FINAL
Environmental Impact Report
Barber Yard Specific Plan
City of Chico, Butte County, California
State Clearinghouse Number 2023030641

Date: September 16, 2026

SECTION 1: INTRODUCTION

Figure 3

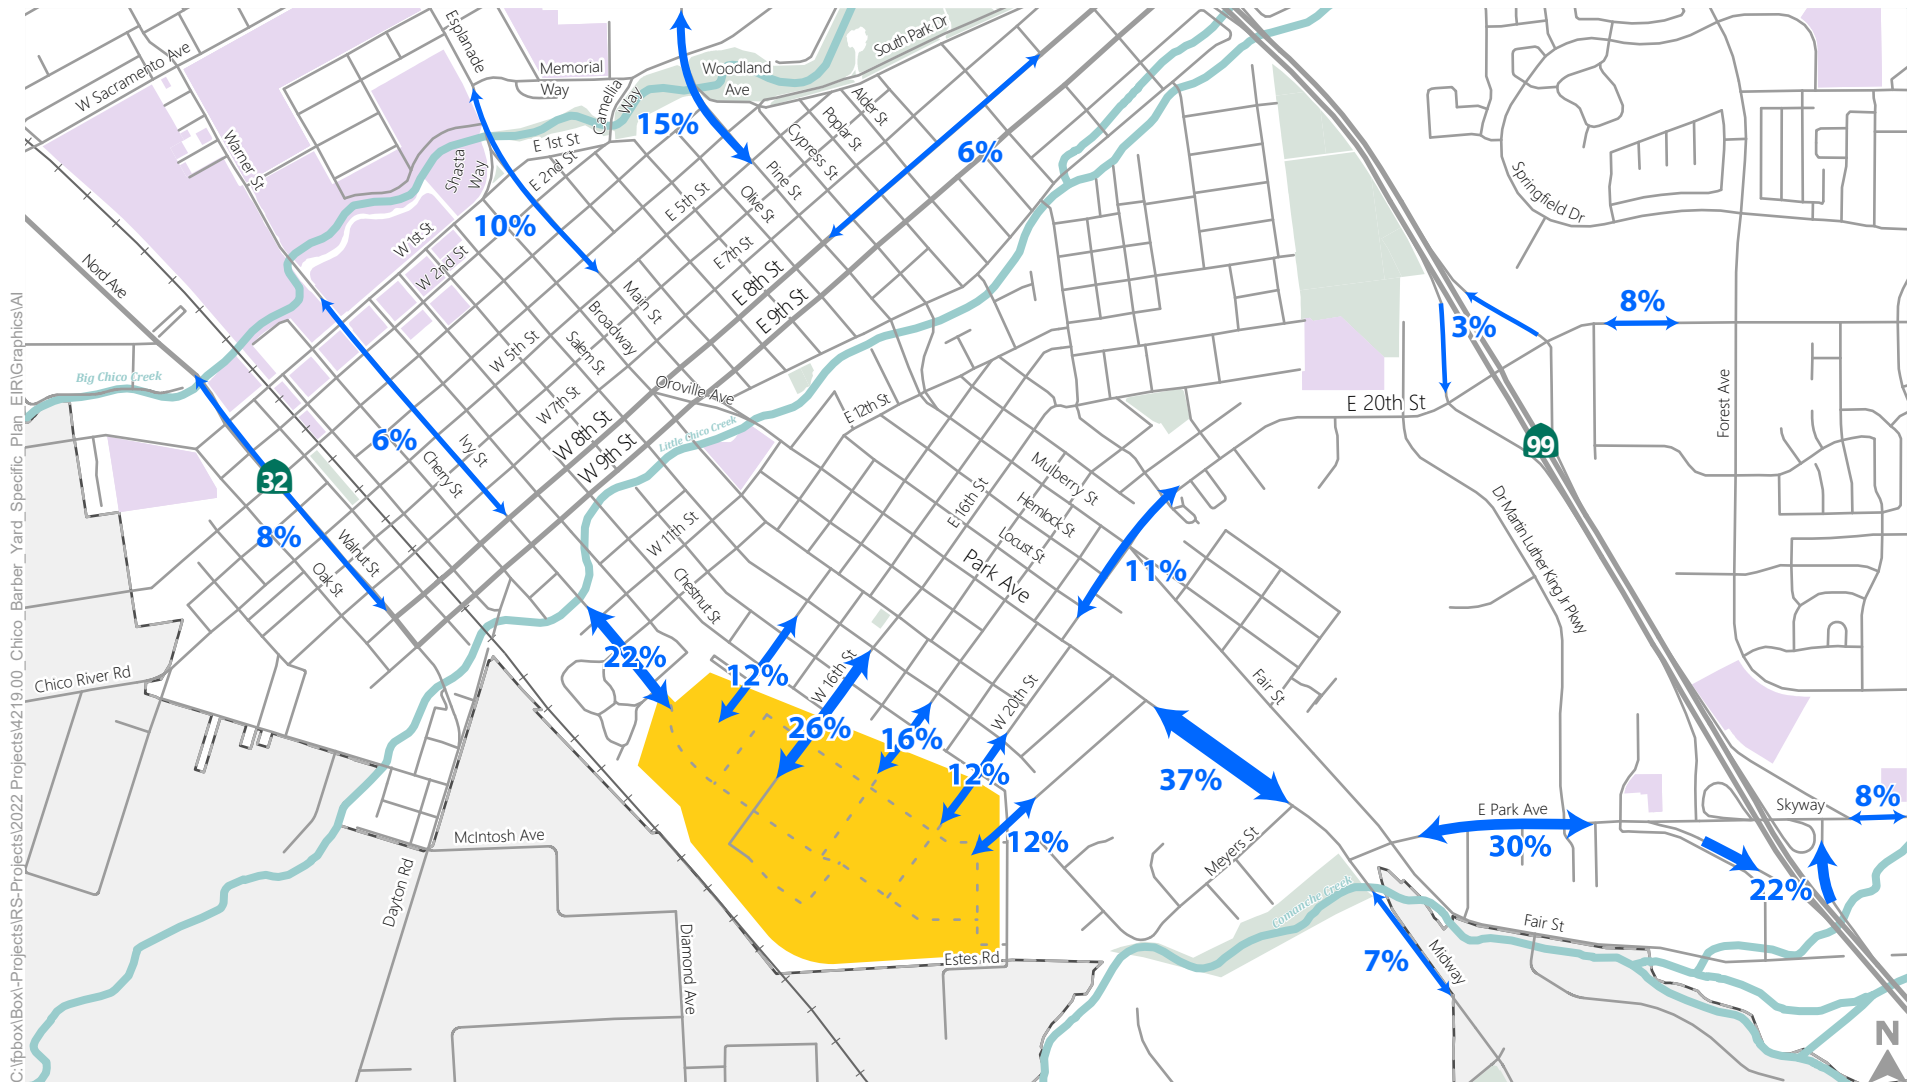
For Figure 3: Project Trip Distribution, the project trip distribution is not clear. The distribution in and out of the project area equals 100%, which is expected. This figure shows that once traffic leaves the project 30% of the traffic is assigned to E Park Ave to and from the Skyway interchange. That is a significant amount of traffic assigned to this interchange and therefore should be included in the analysis. It is unclear how that 30% will be distributed upon reaching the interchange.	6
Please provide clarification of the anticipated truck volumes during construction, and provide information on truck routes during construction. Note that E 20th Street and E Park Avenue are City Surface Transportation Assistance Act (STAA) routes, according to the "City of Chico – Local STAA Truck Route" map. Caltrans recommends that the applicant work with the City of Chico if E 20th Street or E Park Avenue will be utilized during the construction phase.	7

The commenter requests clarification on data in Figure 3 on trip distribution.

Appendix J has been modified to provide additional clarification for trip distribution at the SR-99/Skyway interchange in Figure 3, see Section 4, Errata. The amount of traffic distributed and assigned to this interchange does not change the Draft EIR transportation impact findings.
